Access Compliance Report Public Rights-of-Way (Curb Ramps)

Intersection ID: 10021328Main Street: BLAKENEY_HEATH_RDCross Street: N/ALocation:NEADA ID: F667DBFA27E3Ramp Type: PerpDiagInitial Pass/Fail: FailOverall Compliance: NoSeverity Score: 33.75

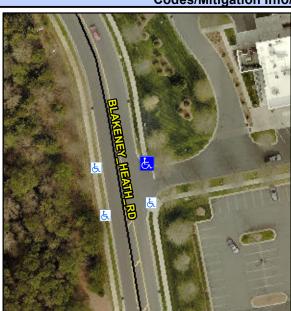
R304.5.1, R304.2.2, R304.5.3

Field Measurements/Component Compliance							
Comp	liance Description	Data	Comp	liance Description	Data		
N/A	Ramp Length (in)	44.0	No	Ramp Slope (%)	9.2		
No	Ramp Width (in)	46.5	No	Ramp XSlope (%)	5.8		
N/A	Flare Type LT	N/A	N/A	Flare Type RT	N/A		
N/A	Flare Slope LT (%)	N/A	N/A	Flare Slope RT (%)	N/A		
N/A	Flare Traversable LT?	N/A	N/A	Flare Traversable RT?	N/A		
N/A	Landing Length (in)	N/A	N/A	DWS Provided?	N/A		
N/A	Landing Width (in)	N/A	N/A	DWS Contrast?	N/A		
N/A	Landing Slope (%)	N/A	N/A	DWS Length (in)	N/A		
N/A	Landing X Slope (%)	N/A	N/A	DWS Full Width?	N/A		
N/A	Landing Curb? (Y/N)	N/A	N/A	DWS Offset (in)	N/A		
N/A	Shared Landing?	N/A					
N/A	Gutter Ponding?	N/A	N/A	Gutter Slope (%)	N/A		
N/A	Gutter Lip Ht (in)	N/A	N/A	Gutter X Slope (%)	N/A		
N/A	Painted X Walk1?	No	N/A	Painted X Walk2?	No		
	X Walk 1 Direction	To W		X Walk 2 Direction	To S		
N/A	X Walk 1 Width (in)	N/A	N/A	X Walk 2 Width (in)	N/A

Remove & Replace Curb Ramp With Two New Directional Ramps or Equivalent.
